RE: 127 Belhaven Drive

I reviewed the drawings and evaluated the neighborhood context. My comments and recommendations on the design are as follows:

ISSUES AND CONCERNS

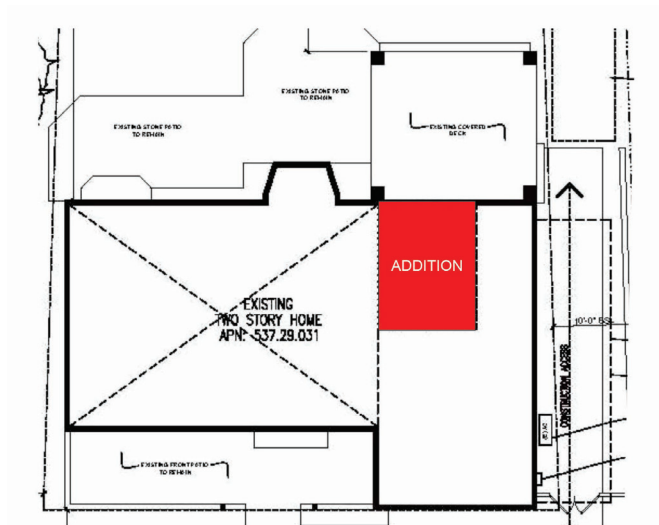
The proposed second floor addition is modest in size and the home would be consistent with similar homes in the immediate neighborhood. Windows and details match the existing house in conformance with the Residential Design Guidelines. There is one element that I believe would not be consistent with the architectural style and the neighborhood. That is the proposed deck on the front facade which is embedded in the garage roof, quite awkward and totally different than any nearby home. As noted in the illustrations below, it also is not a great outdoor space for the home with three sides of the deck consisting of tall walls.

RECOMMENDATIONS

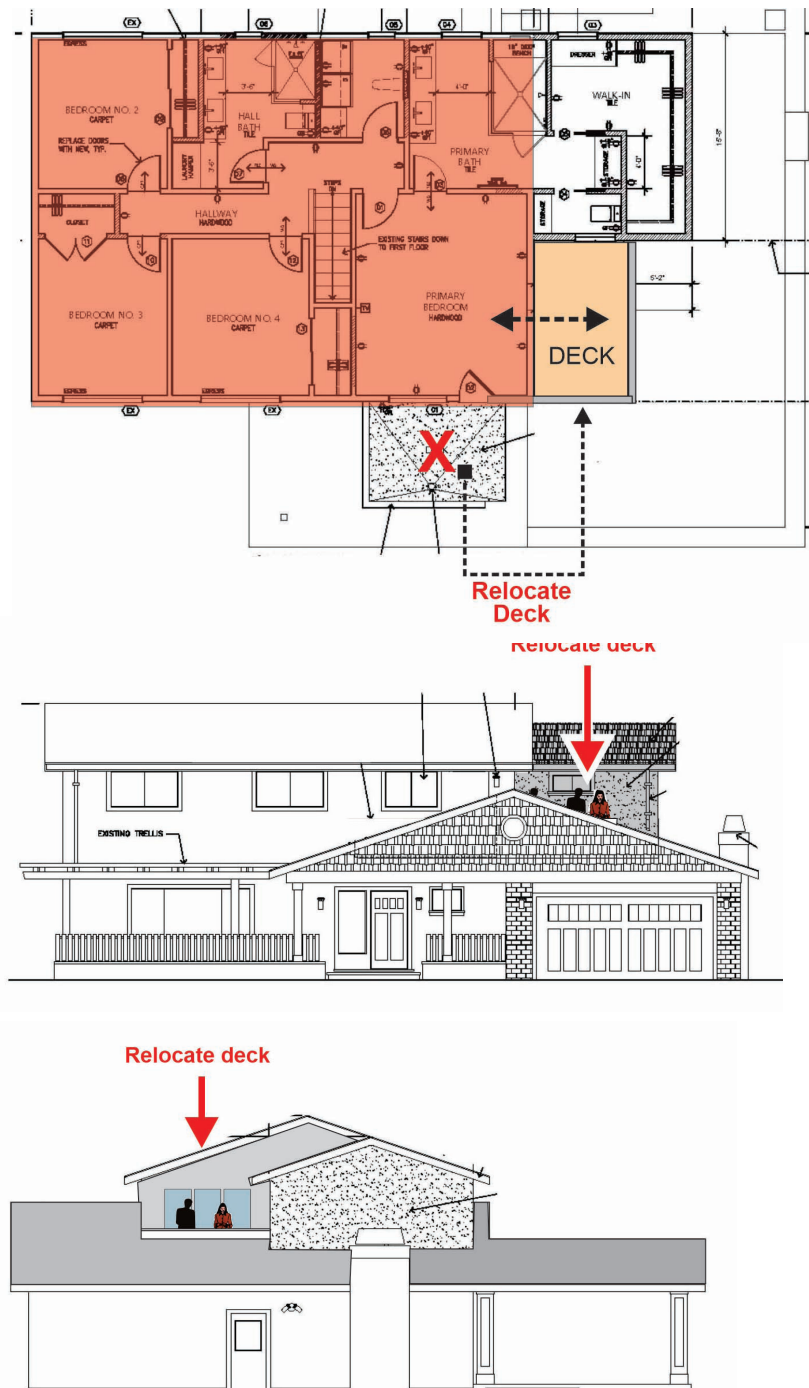
The most consistent recommendation would be to remove the deck from the front elevation. However, if the applicant can make a credible argument for including a balcony off of the Primary Bedroom, my recommendation would be to relocate it to the side facade as shown in the illustrations below. This would keep the front facade consistent with other homes in the immediate neighborhood, provide a more pleasant space for the homeowner, and would not create any privacy concerns for the adjacent home since its side facade is largely a blank wall.

The deck depth should be modest in depth to minimize its intrusion into the roof form visible from the street.
